40-C-26

2003-0254  
Application I. D. Number  
11/25/2003  
Application Date  
Guilford Court  
Project Name/Description

**TO: Rick Knowland --Senior Planner**  
**FROM: Jim Seymour – Development Review Coordinator, Sebago Technics, Inc.**  
**RE: Proposed Residential Building: 155-159 York Street**  
**DATE: February 20, 2004**

**PLANNING BOARD REPORT #9-04**

EXTERIOR ELEVATION

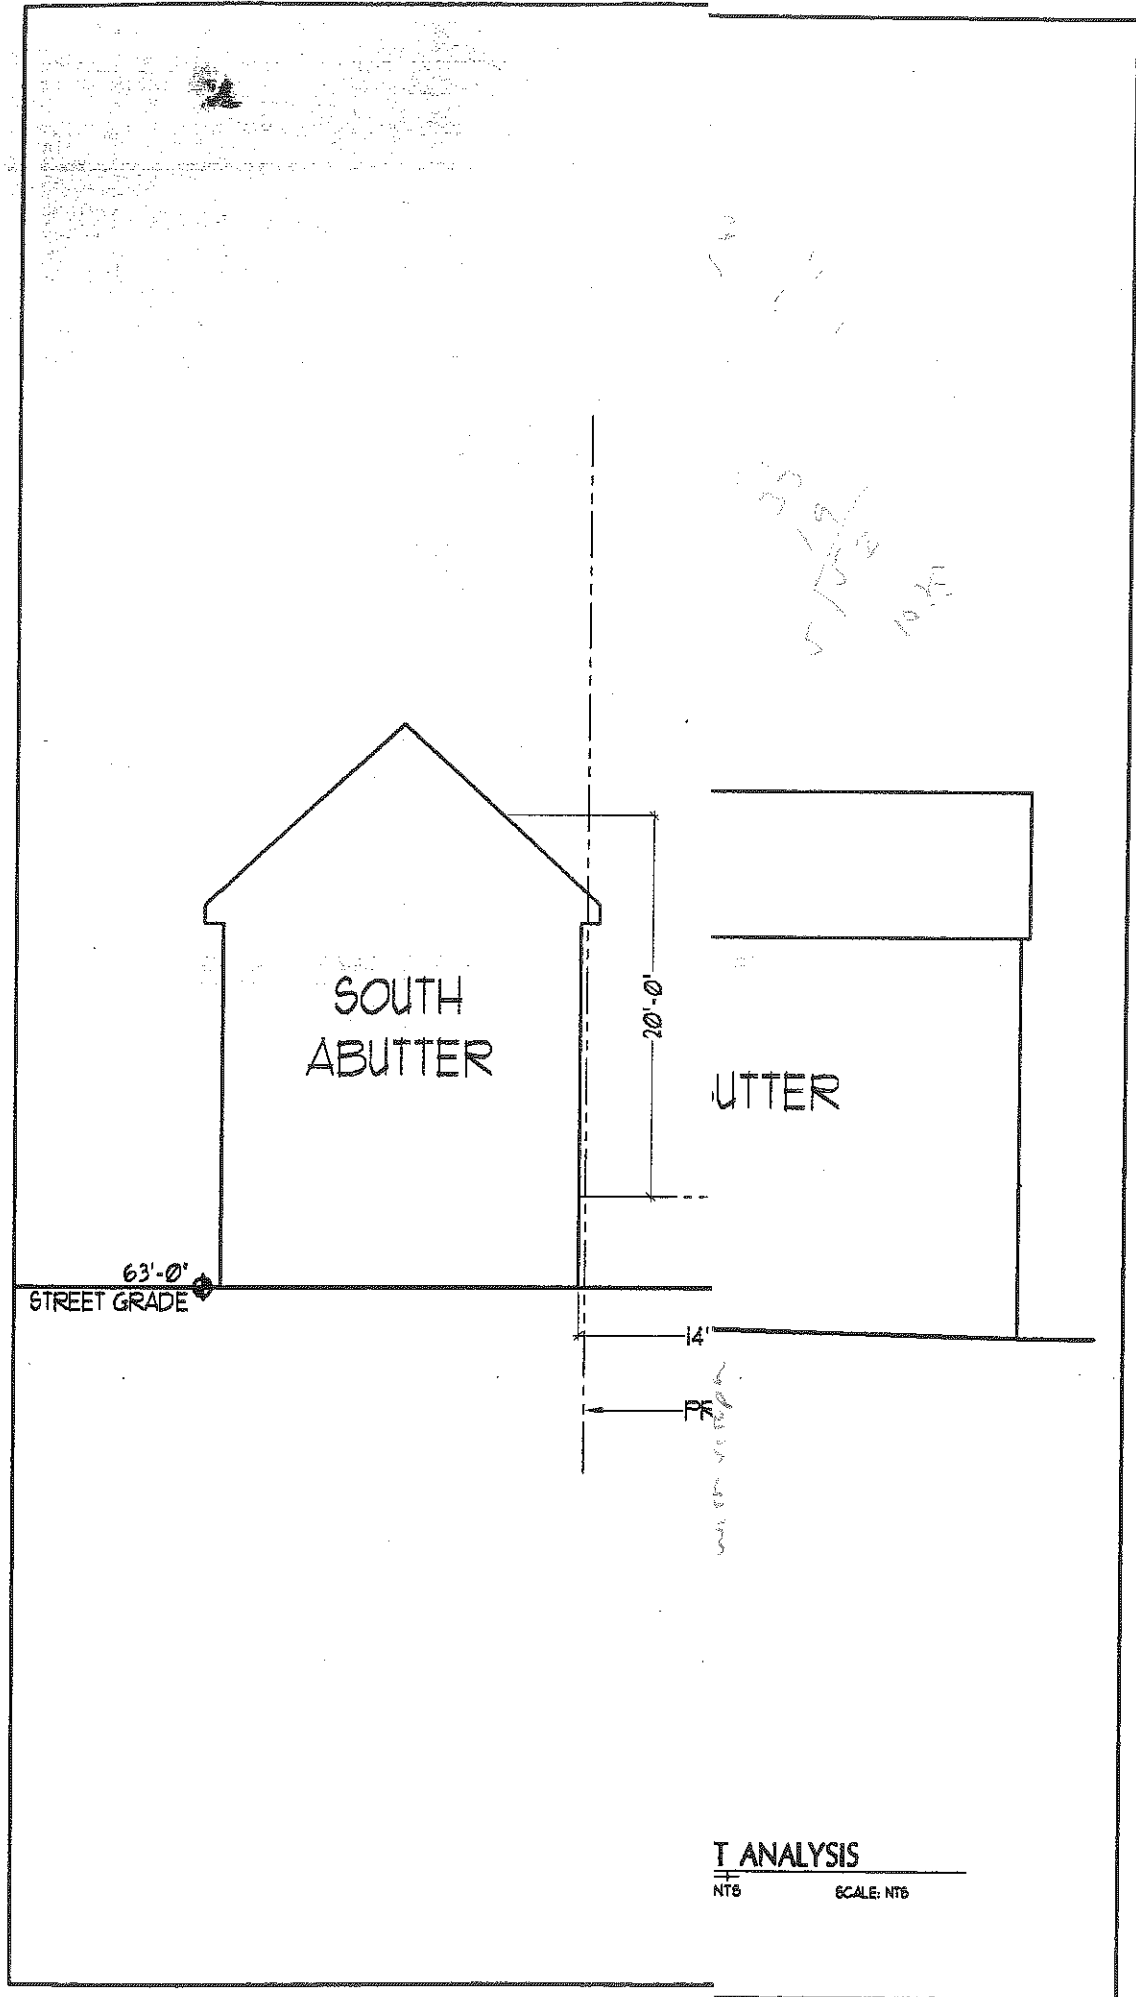
10. Building elevation...Label the following on the plan. Indicate width of window trim and cornerboard trim. Projection of eave and rake. Width of cornice. What will be the materials used along the facade? One suggestion. Use a masonry material along the foundation level of the building.

*Building facade  
was revised under  
the R-6 Design  
Principles and Standards*

The design of the building fits in well with its surroundings. See building elevations (Attachment B). The two large gables along York Street break up the long expanse of the roof line. A pronounced main entry, plenty of windows, porches, trim (for windows, doors and corner boards) provides a visually interesting façade that is well articulated. The plan indicates the façade will have an exterior of WD clapboards. The York Street side foundation will have a brick base foundation while the remaining sides will be concrete.
